Re: Blair Development, 503 Third St. NW, Certificate of Occupancy
Engineer's Stamp dated 5-12-03 (J14/D135)
Certification dated 12-11-03

**Re: Blair Development Grading and Drainage Plan
1500 3rd St. NW
Engineer's Stamp dated 5-12-03, (J14/D135)**

**Re: John Blair Project Site Plan submitted for Traffic Circulation Layout
1500 3rd St. NW
Architect's Stamp dated 4-23-03, (J14/D135)**

Re: T.C.L. submittal for building permit approval for Blair Development, XXXX Constitution N.W.
Anderson Addition, Block 3, Lots 8-11, [J14/D135], No Architect's Stamp.

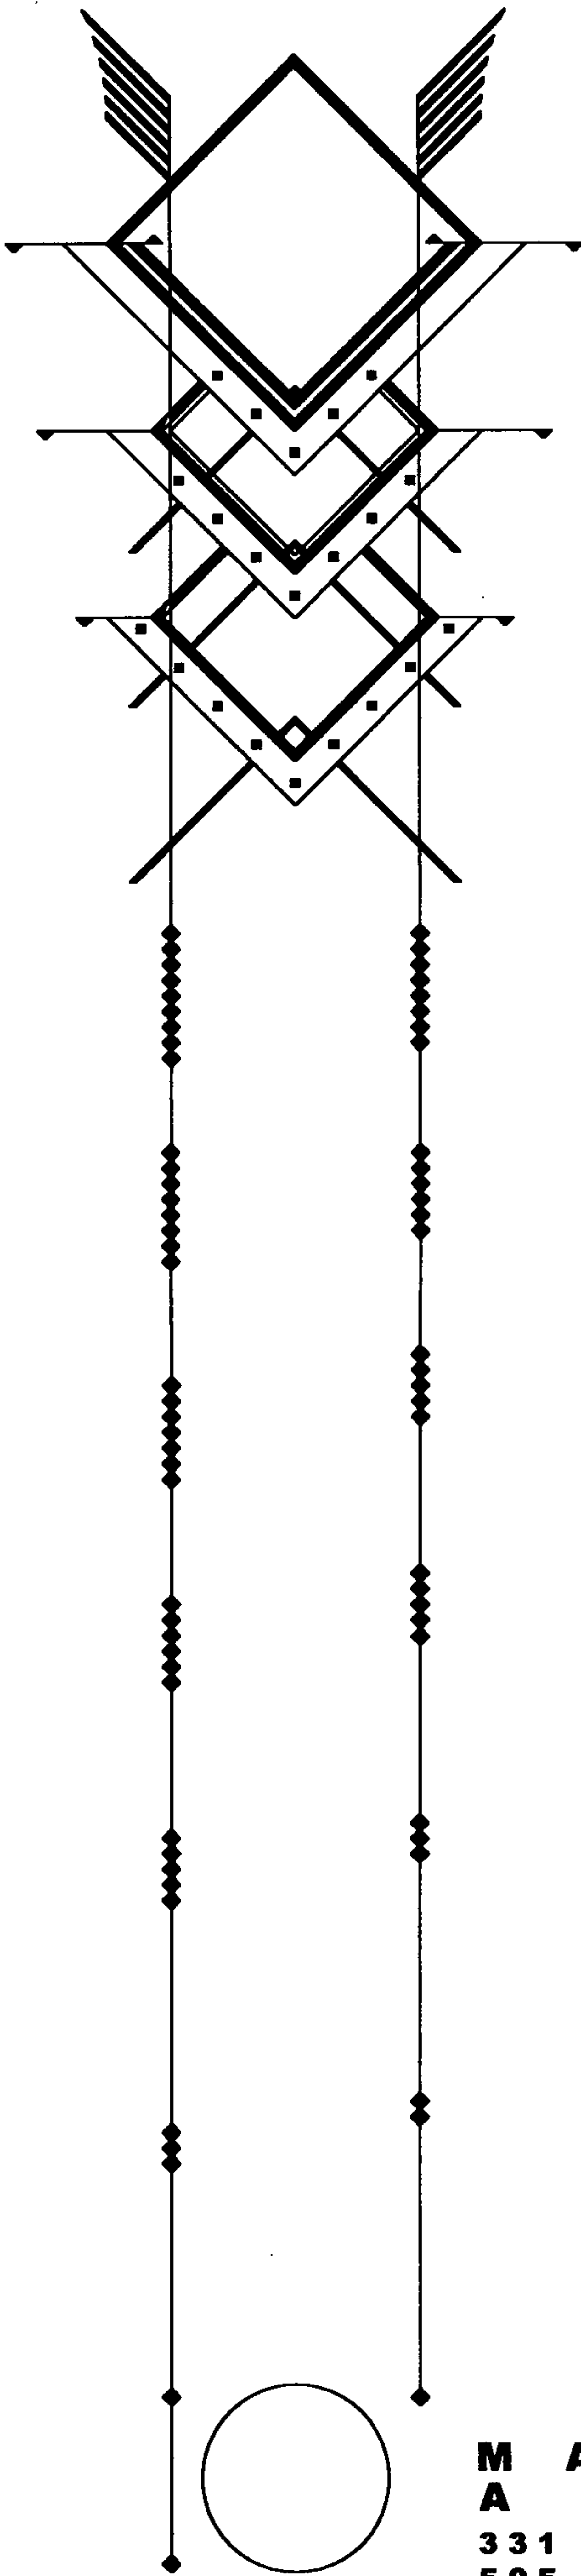
Based upon the information provided in your submittal dated 4-24-03, the above referenced plan cannot be approved for Building Permit until the following comments are addressed.

- A lot consolidation replat or cross access and parking easements must be submitted prior to Building Permit approval.
- The driveway on Constitution should be a maximum of 30' wide.
- Please denote that the northernmost parking spaces are for employees only.
- Please denote type of delivery vehicle expected and add turning templates to the plan.

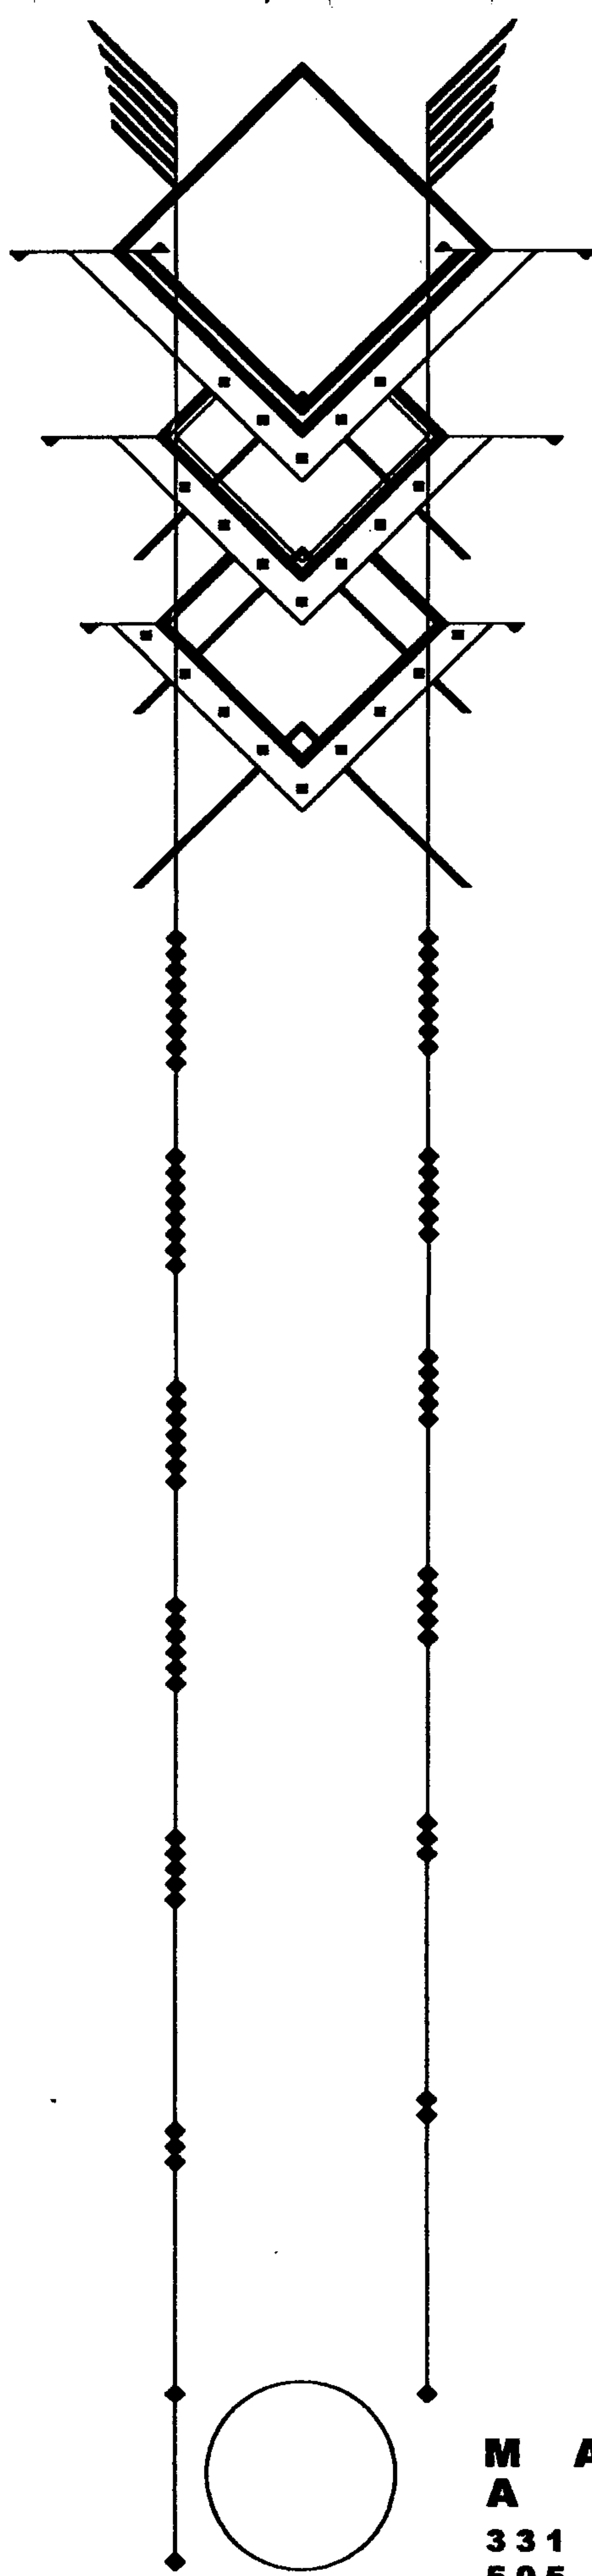
- T.C.L.(Site Plan) must be stamped and stamp must be dated.
- For this Plan, and all others following, submit street address of site. Could be part of title block or application sheet in Hydrology file. Also call out name of subdivision and lot number and/or tract number.

- Need to see clear differentiation between new construction and existing on T.C.L. _Show, label, and dimension existing and/or new street sidewalk construction. City sidewalk ordinance requires minim. 4' street sidewalks along the frontage of all commercial sites being developed. _Any new sidewalk construction must be built so back of sidewalk is at Right-of-way (property) line.

- Need to know what size vehicle will be largest to use site, and route. _Proposed use of overhead doors on commercial sites requires that plan reviewer looks for large wheelbase (refuse/UPS) vehicle to be smallest to use doors. This site layout will not allow enough room for this condition without backing from or into street. This violates provisions in the DPM, Sect. 23.6B.8b.2 & 23.7B.8.

- Show and label new or existing H.C. ramp at street corner, must be A.D.A.
- Place concrete wheel stop only at front of H.C. stall, 18'-0" from rear of stall, use #6 rebar anchors, 18" in length. Note on T.C.L.

- Using traffic turning template, TCL layout is not designed to allow safe, effective use by refuse vehicle, as shown, without violating Development Process Manual - Chapter 23, Section 6B.8b.2 & Chapter 23, Sect. 7B.8.
